**CHECK AND SET IGNITION TIMING IN ADVANCED POSITION
ELECTRA GLIDE / SPORTSTER / SERVI-CAR**

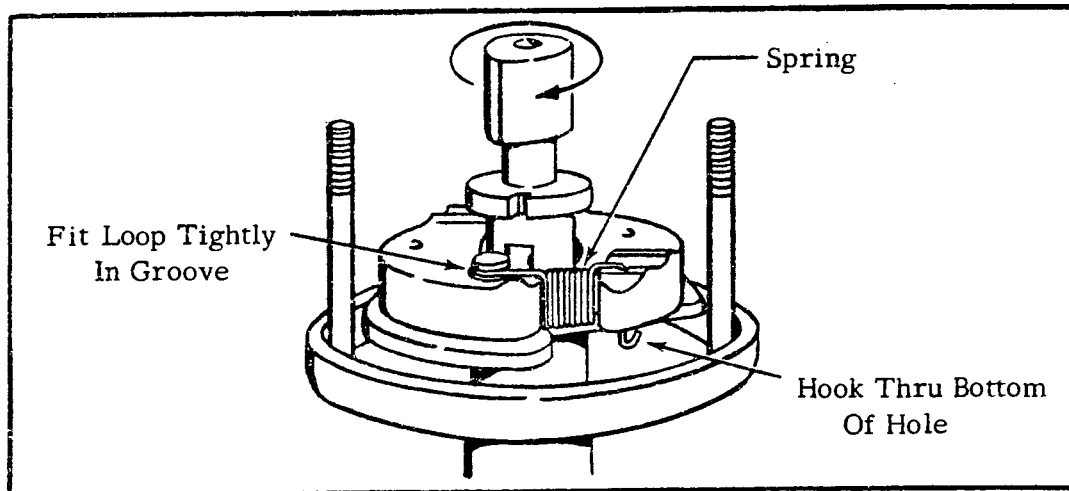
When checking or setting timing with a circuit tester or Strobe timing light according to procedure in Service Manual, ignition should occur when single mark on flywheel is in center of inspection hole in crankcase.

Note that cam must be turned clockwise with flyweights against stops, and held in this position while checking timing with a circuit tester. If a Strobe light is used engine must be run at 2000 RPM speed to be sure cam is fully advanced.

An increase in wire size of the two timer weight springs was made, starting January 3, 1969, to raise the engine speed at which timer advance occurs. This assures that the spark timing will be fully retarded at cranking speed, and will advance gradually as engine speed increases until fully advanced position is reached.

Spring Size	Part No.	Fully Advanced
New (.022 Wire)	32605-69	@ 1600 RPM
Old (.016 Wire)	32605-67	@ 900 RPM
